TECHNICAL RESPONSE TO THE *REVIEW OF THE BIRD CRITIQUE* WITH RECOMMENDATIONS FOR FURTHER ACTIONS

Submitted to the Diablo Canyon Independent Safety Committee
on behalf of San Luis Obispo Mothers for Peace, Friends of the Earth,
and Environmental Working Group
by Peter Bird, Ph.D
Professor Emeritus
Department of Earth, Planetary, and Space Sciences
University of California Los Angeles
6 June 2025

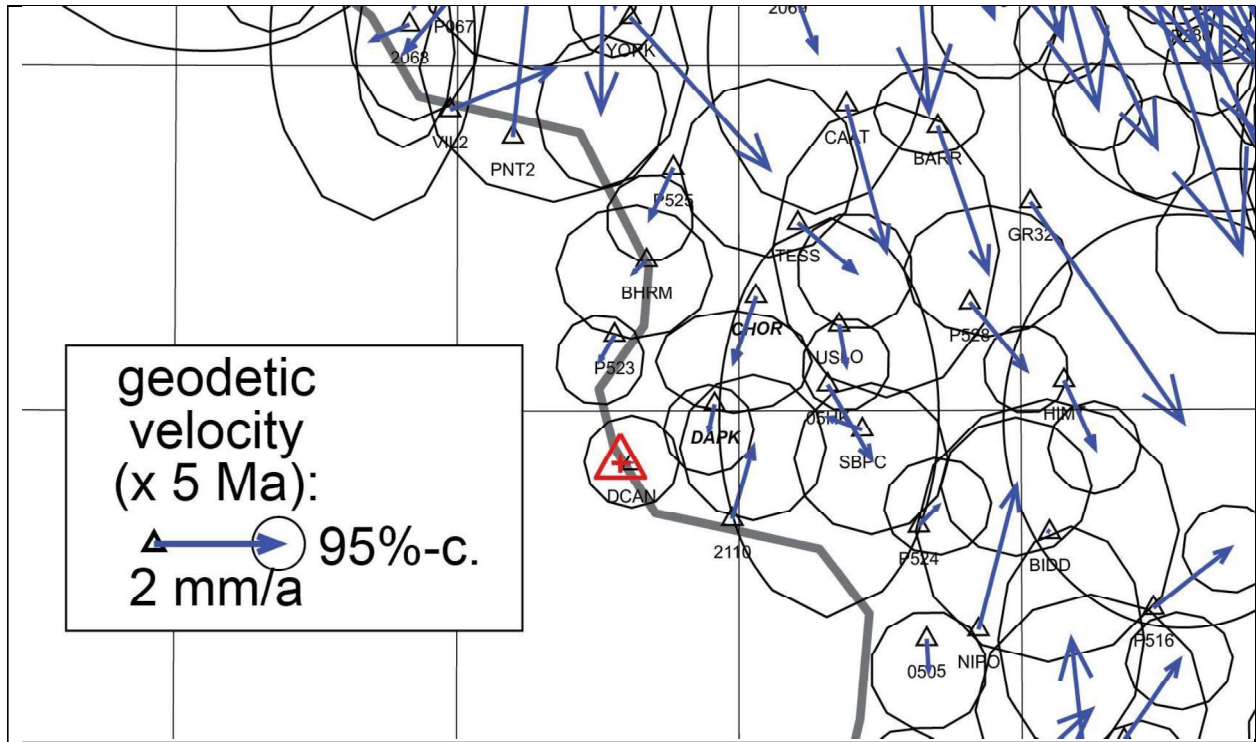
The SRT objected that my treatment of GPS was initially opaque, and then simplistic in two different ways. Specifically: (1) “*We were unable to reproduce these shortening estimates*” that I quoted; and (2) when interpreting interseismic strain-rates, it is necessary to estimate how much comes from distant faults; and (3) when interpreting NNE-SSW shortening, it is important to recognize that both strike-slip and thrusting can be involved. I will answer each in turn.

1. Station-to-station velocity differences. I used the *Zeng* [2022] dataset with no modifications. I plotted the velocities (and their confidence ellipses) with my publicly-available program NeoKineMap. And I used the option, in that program, to change the velocity reference frame by adding a simple Eulerian rotation-rate to the entire dataset; I chose an Euler pole that keeps the Irish Hills stationary and non-rotating. Such an operation is extremely common in geodesy, and has absolutely no effect on baseline rates or strain-rates, which are contained in velocity differences and derivatives, not in (frame-dependent) absolute velocities. (In fact, the SRT also removed the velocity of DCAN, but did not remove the local rotation.) The result is shown in Figure 1, which I also provided to the SRT at our 18 March 2025 meeting.
